McCUMSEY, LLC

Re: 175-177 Grove Avenue
Verona, NJ
SITE PLAN – ENGINEER'S COMMENTS (02/05/07)

Re: 175-177 Grove Avenue
Verona, NJ
RETENTION SYSTEMS

DRAINAGE REPORT

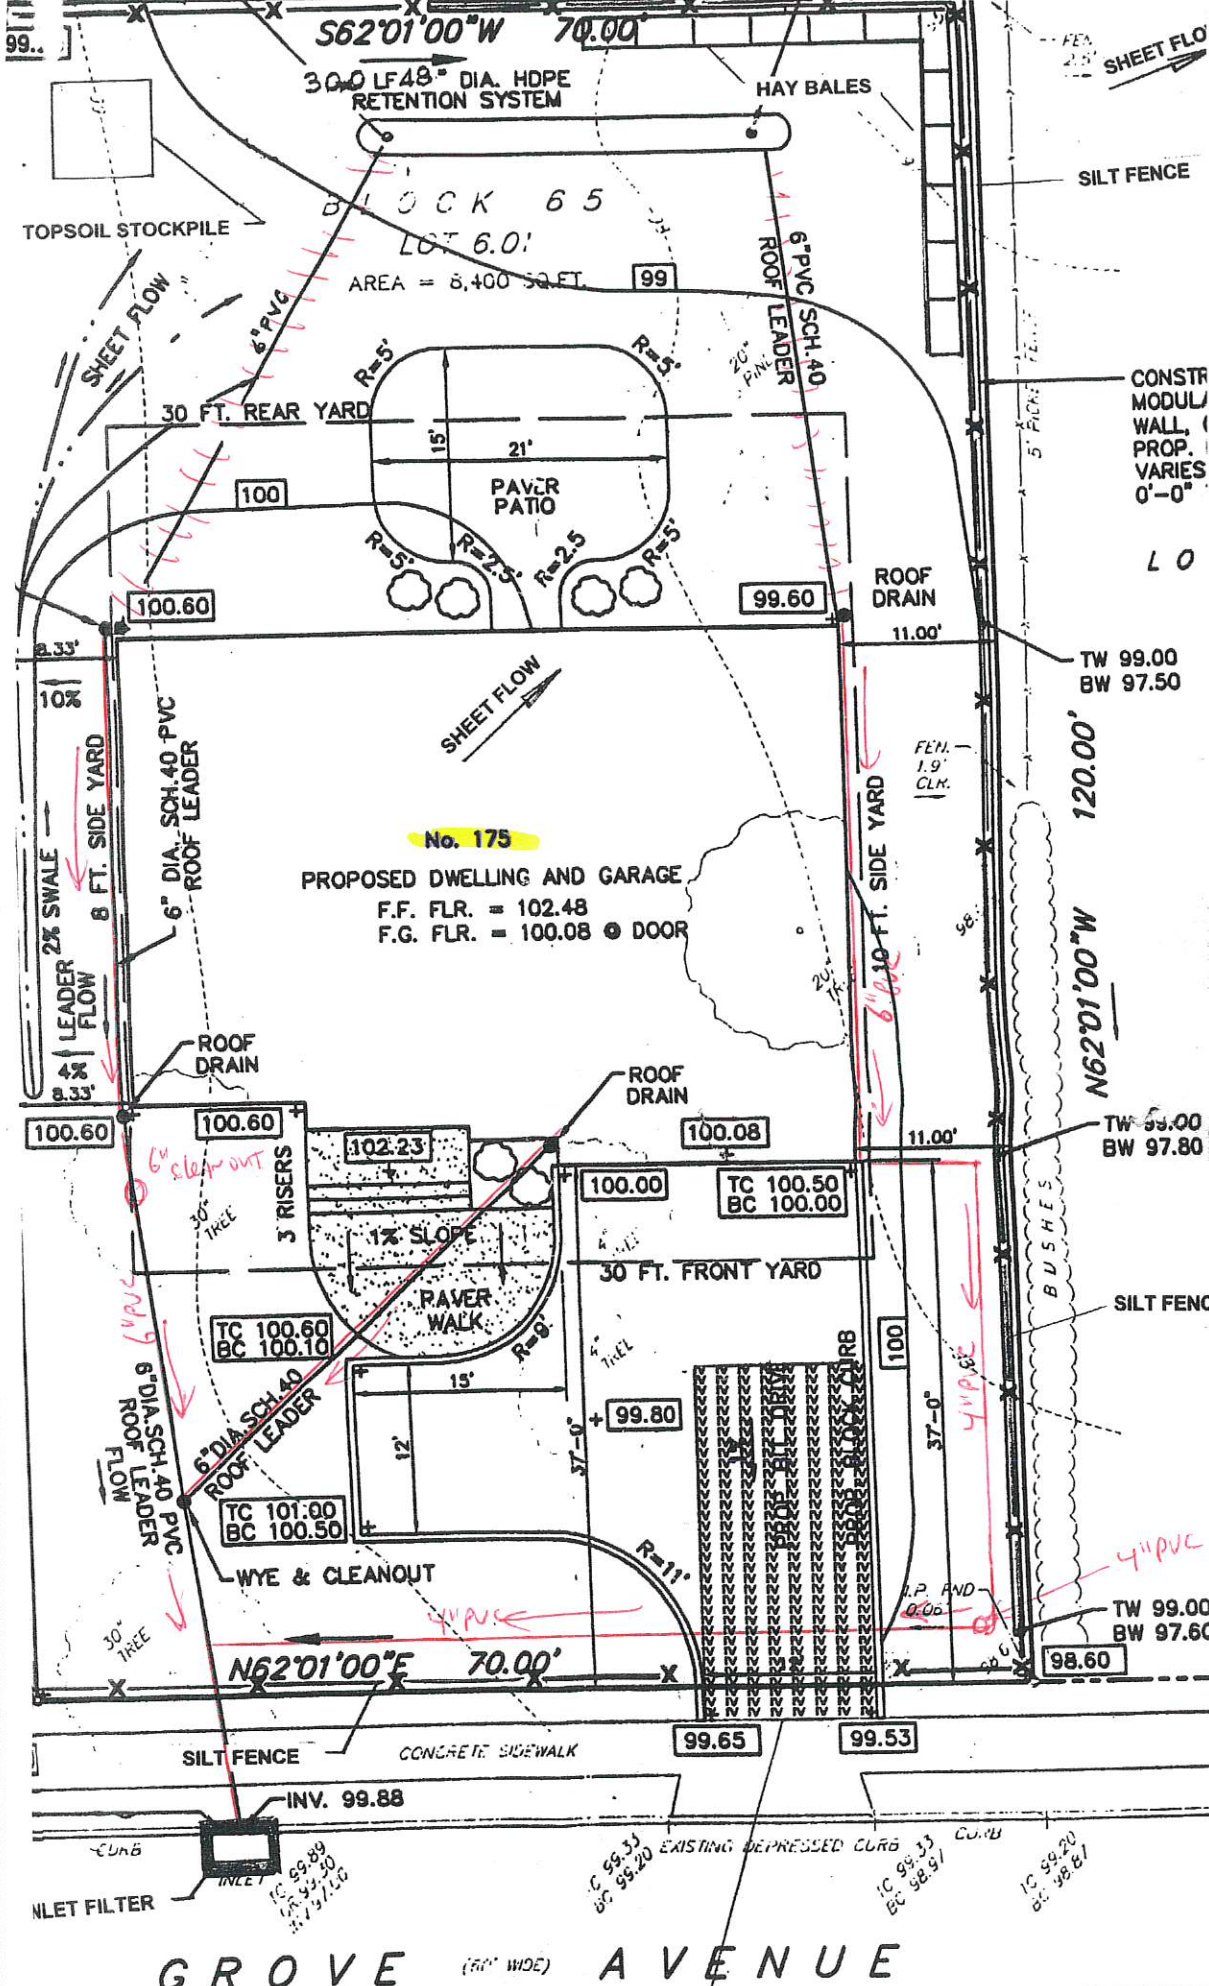
Attached you find a revised drawing of the storm water piping for the above referenced homes. As directed, all storm water piping has now been directed to the catch basin on Grove Avenue and two retention systems are now decommissioned.

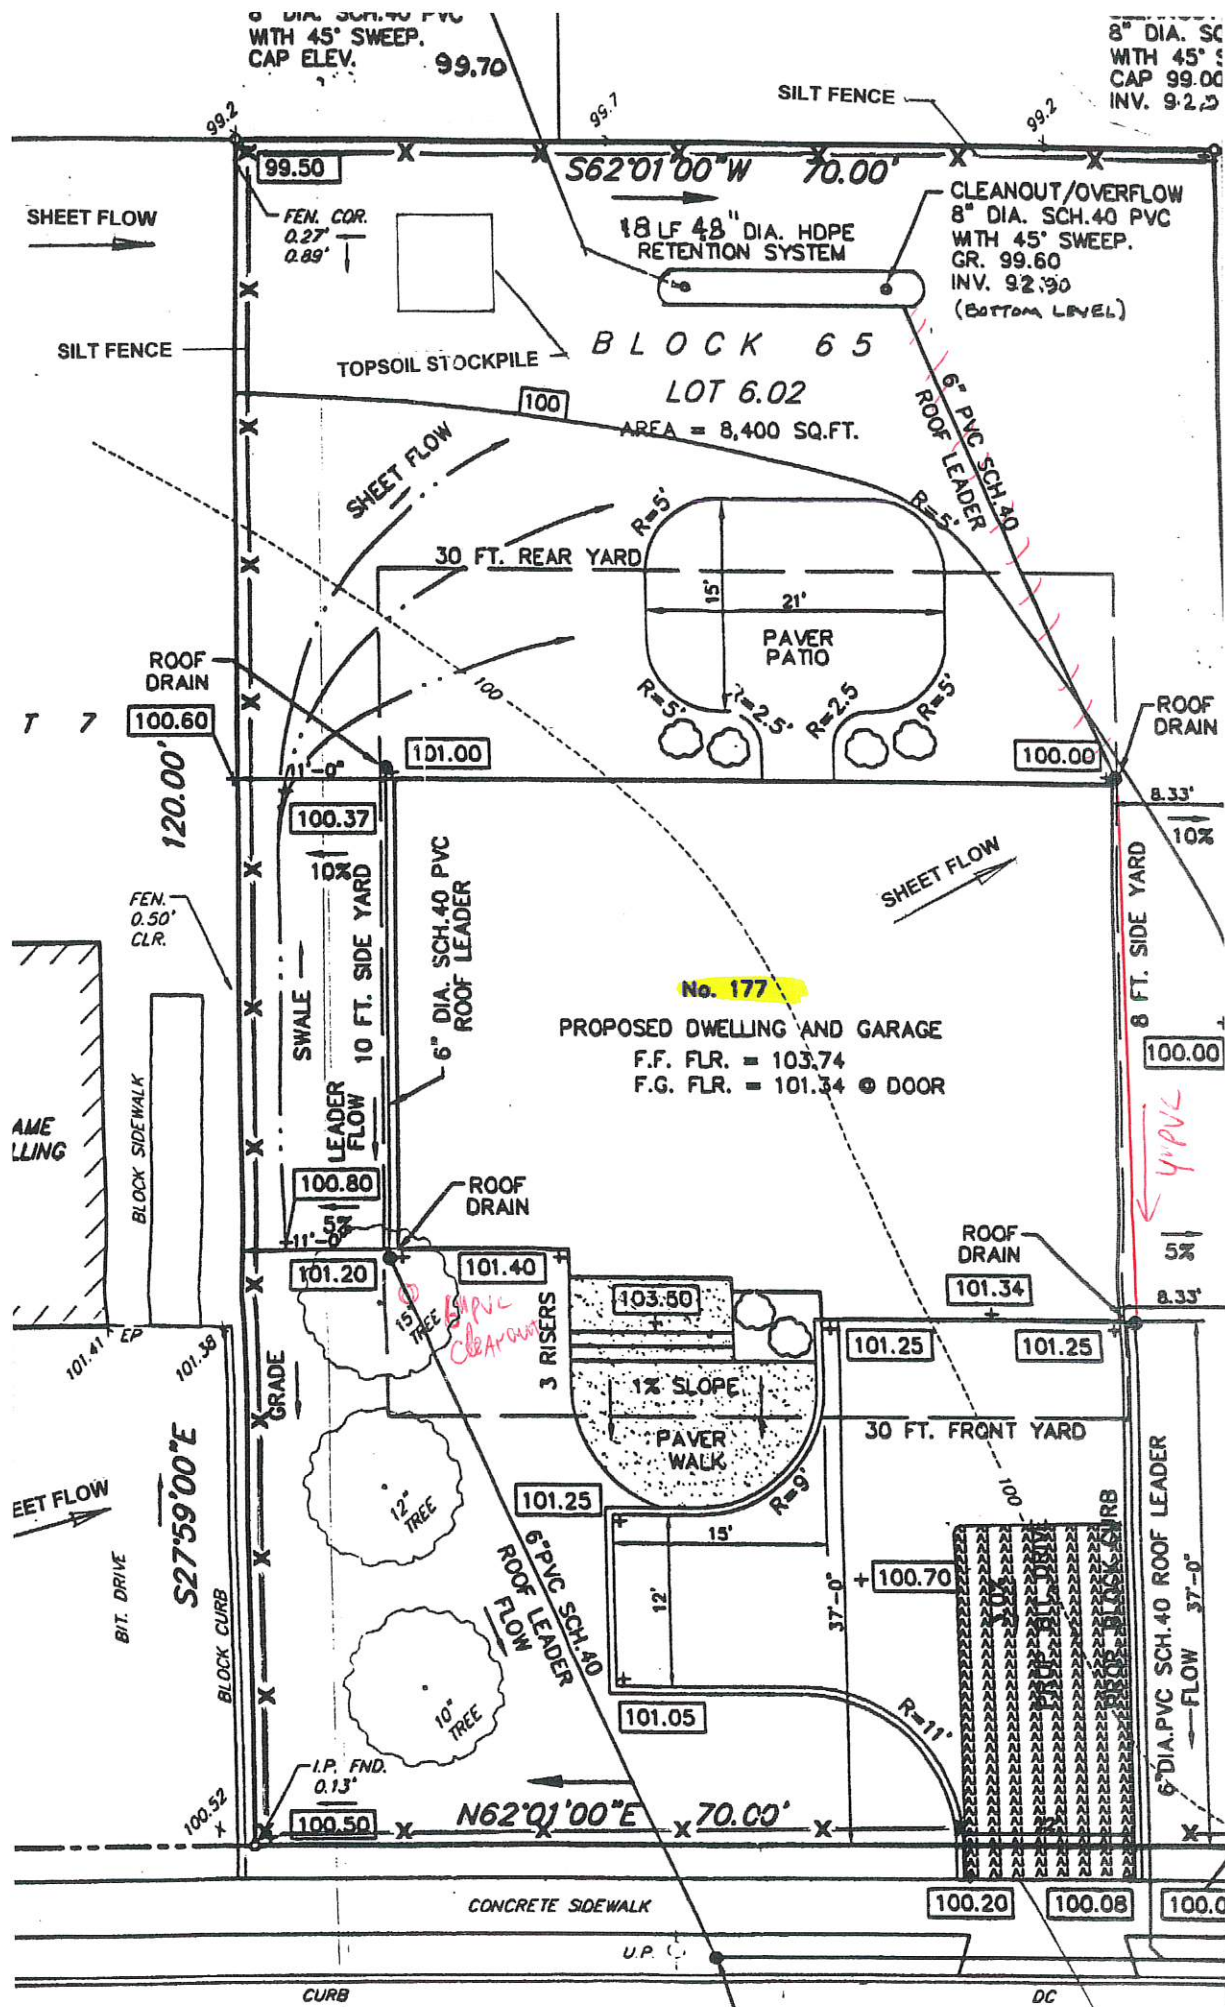
5. Water-tight cap was to be set at 98.80 (several inches below grade). It has now been set flush with the surface at 99.70. Actual elevation can vary as long as it is flush or out of harm's way.

8" DIA. SCH. 40 PVC WITH 45° SWEEP. CAP ELEV. 99.70

8" DIA. SCH. 40 PVC WITH 45° SWEEP. CAP ELEV. 99.00 INV. 92.20
